Product Change Notification: CAAN-02PELF720

CCB 6779 Final Notice: Qualification of ANAP as an additional assembly site for ATSAM3S8CA-AU, ATSAM3S8CA-AUR, ATSAM3SD8CA-AU and ATSAM3SD8CA-AUR catalog part numbers (CPN) available in 100L LQFP (14x14x1.4mm) package.

PCN Type: Manufacturing Change

ASSH

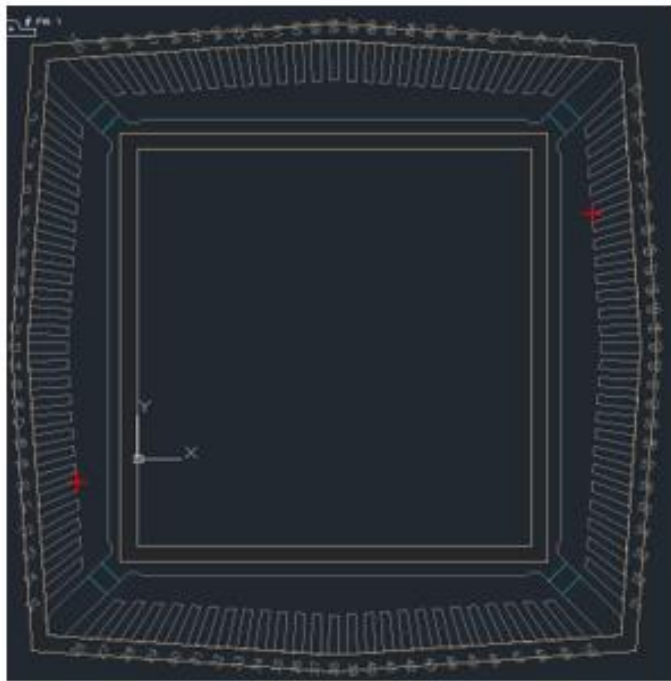
Wire Material	Au
Lead Frame Material	C7025
Lead-Frame Paddle Size	240X240 mils

ANAP

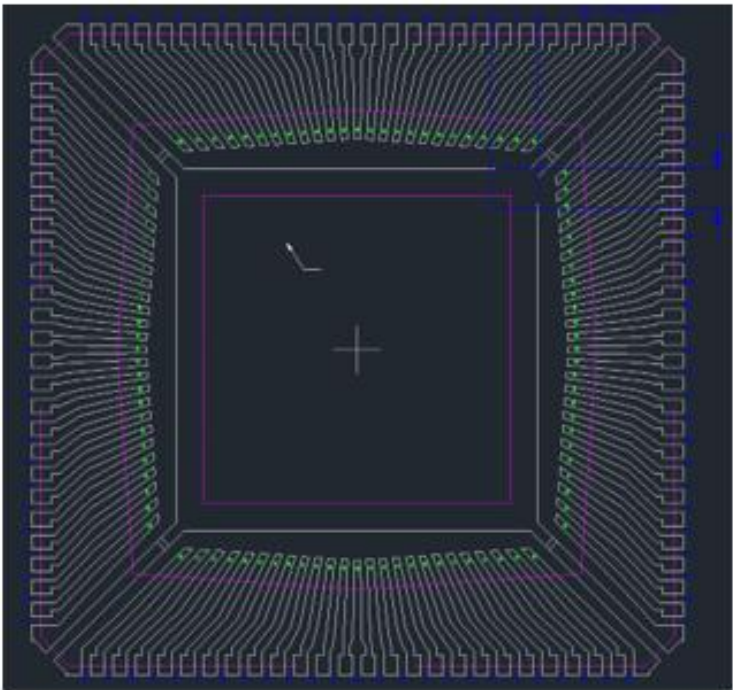
Wire Material	Au
Lead Frame Material	C194ESH
Lead-Frame Paddle Size	315X315 mils
